RE: Informal Data Response, Set 6D
San Francisco Electric Reliability Project (04-AFC-1)

**INFORMAL DATA RESPONSE,
SET 6D**

**(Responses to: Informal Data Response Set 6, Sarvey Data Request Set
1A, and Preliminary Staff Assessment Soil and Water)**

Rainfall Intensity Duration Frequency (IDF) Curve
 Department of Water Resources Rain Gauge
 San Francisco International Airport

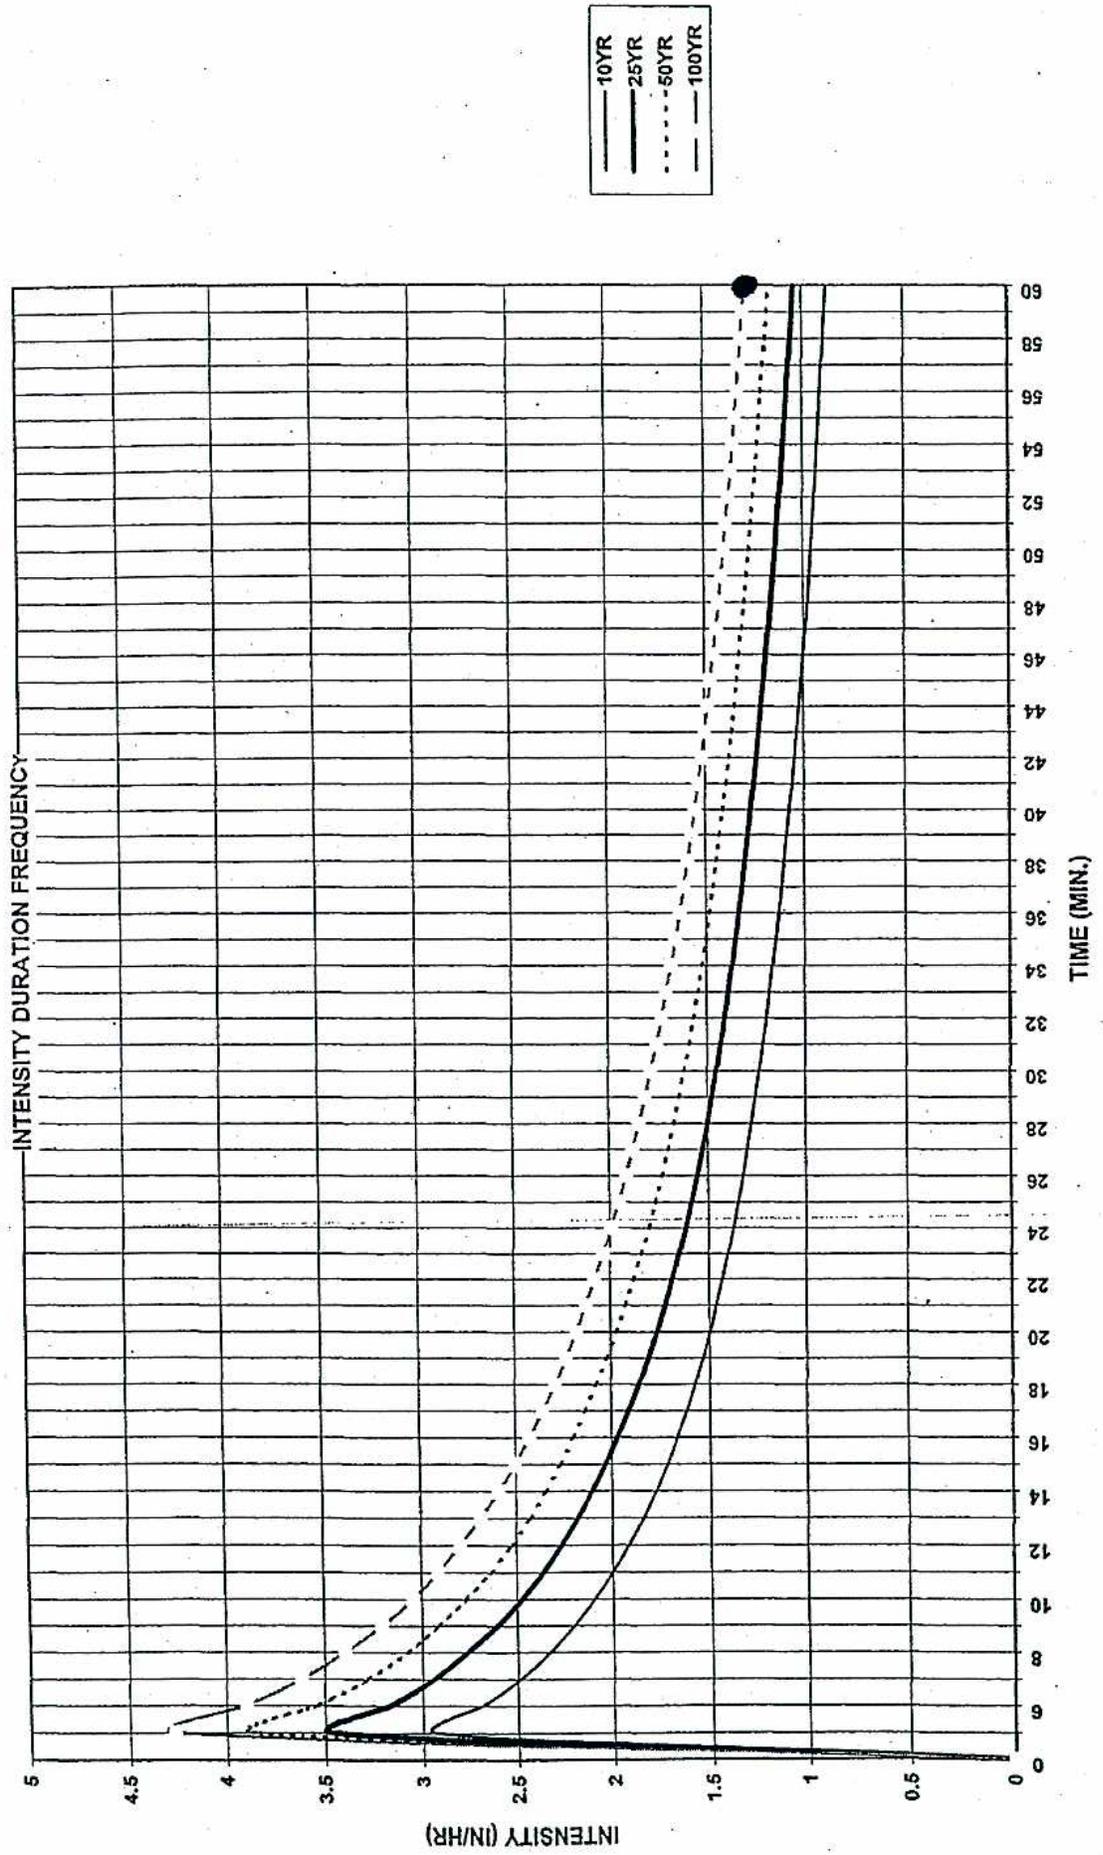
Preliminary Staff Assessment (P. 4.9-21, Storm Water, 2nd and 3rd paragraphs): Prior to publication of the FSA, staff requests that the applicant provide evidence from the Port of San Francisco and the SFBRWQCB that no peak attenuation of stormwater from the site will be required and that the proposed vegetated swales can convey the 100-year peak runoff from the SFERP site.

Preliminary Staff Assessment (Conclusions p. 4.9-33): In order to complete the FSA, staff requires the following items be submitted:

- Evidence from the Port of San Francisco and the SFBRWQCB that no peak attenuation of post-construction stormwater flow from the site will be required.
- Evidence from the Port of San Francisco stating that the SFERP will be covered under the Port's NPDES permit.
- Evidence that the proposed vegetated swales can convey the post-construction 100-year peak runoff from the SFERP site. A map showing the location, alignment and dimensions of the vegetated swale. Provide engineering details for the stabilization methods to be used to protect the vegetated swale at the point of outfall to the SF Bay.

A plot of this IDF curve is attached, which indicates that for a 100-year frequency and 1-hour duration storm the Intensity "I" = 1.28

Attached please find a spreadsheet detailing that the swale will carry in excess of the 100-year peak runoff at a depth of 0.90 feet.
